ENGINEERING CHANGE NOTICE

1. ECN ~~131460~~
 Proj. ECN B-714-81

Block 5: B-714, Grout Vault Pair (218-E-16-102 & 103)(218-E-16-104 & 105)/ER8007

VAULT 218-E-16-104 THERMOCOUPLE ARRANGEMENT PLAN

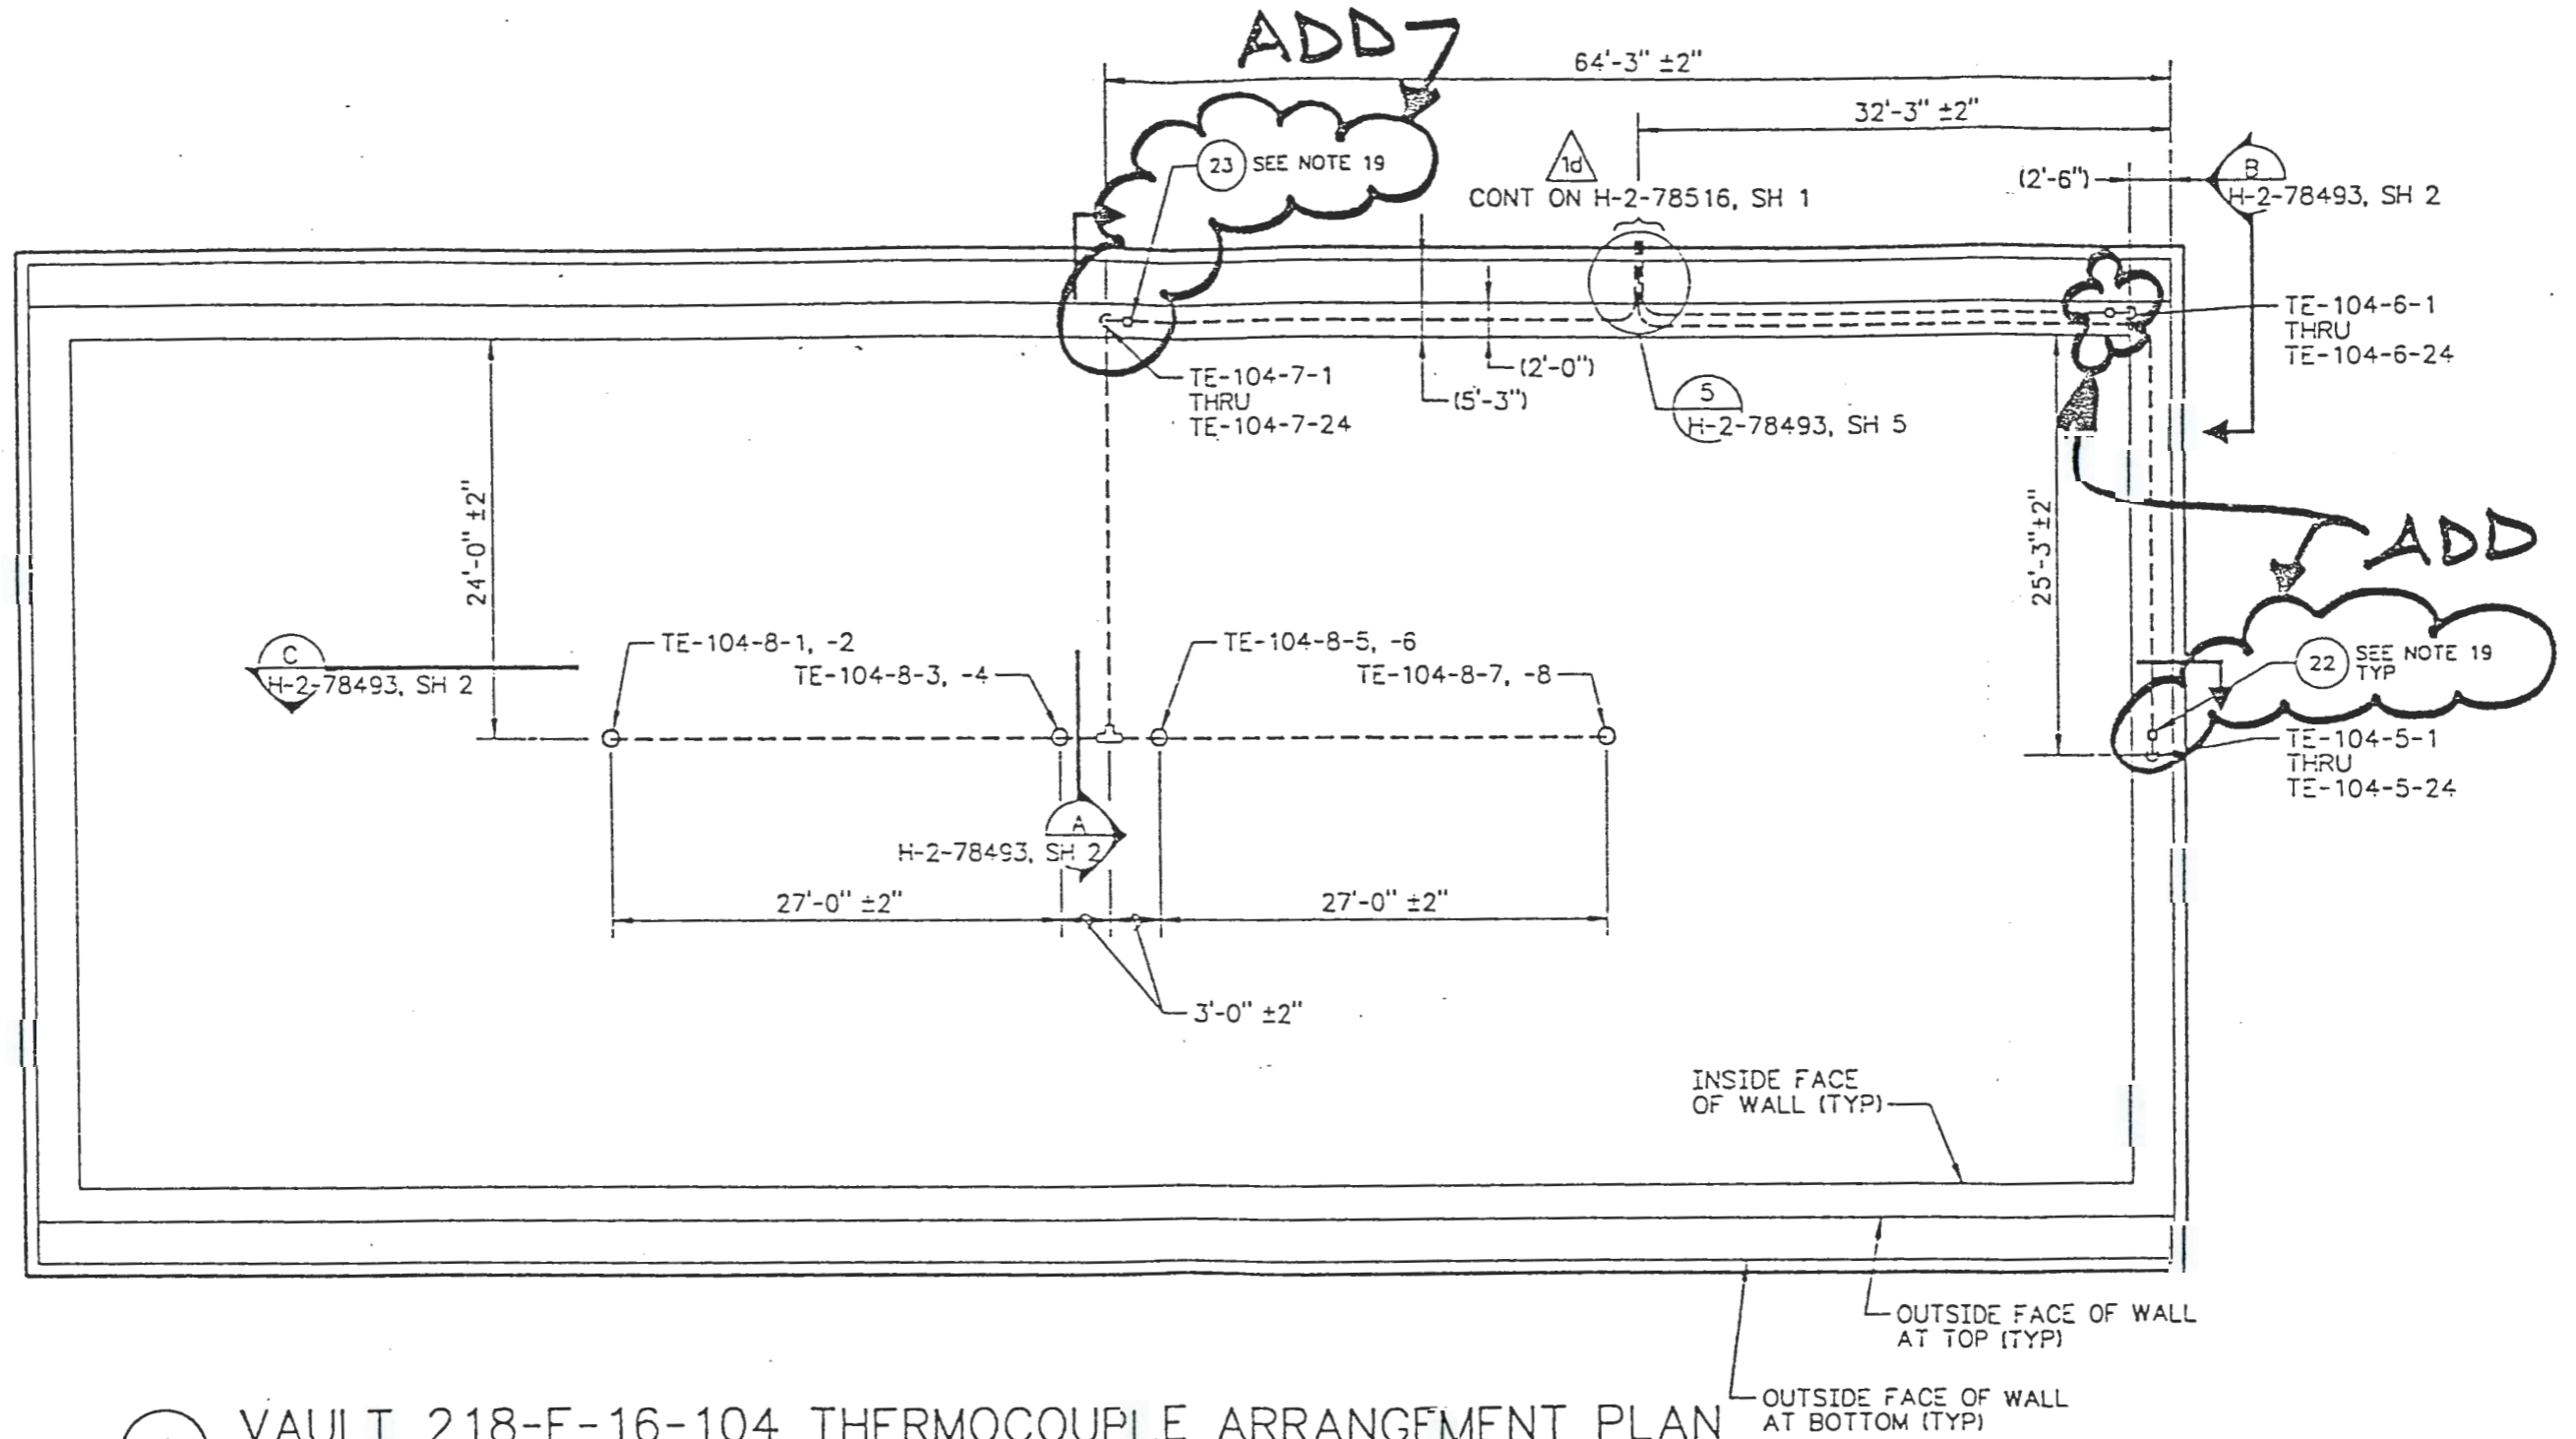
- A) Arrange Plan 1 (Z F6, E4): Add PN 22 & 23 as shown on page 9 of this ECN.
- B) Arrangement Plan 2 (Z C4, B6): Add PN 22 & 23 as shown on page 10 of this ECN.
- C) Add note 19 as follows (Z F4):
19. TYPE C CONDULET CONDUIT BODIES MAY BE USED WHERE SHOWN AND AT ANY OTHER LOCATIONS NOT SHOWN THAT WILL AID CONSTRUCTION.
- D) Parts Lists (Z D1-2): Add PN 22 & 23 as follows
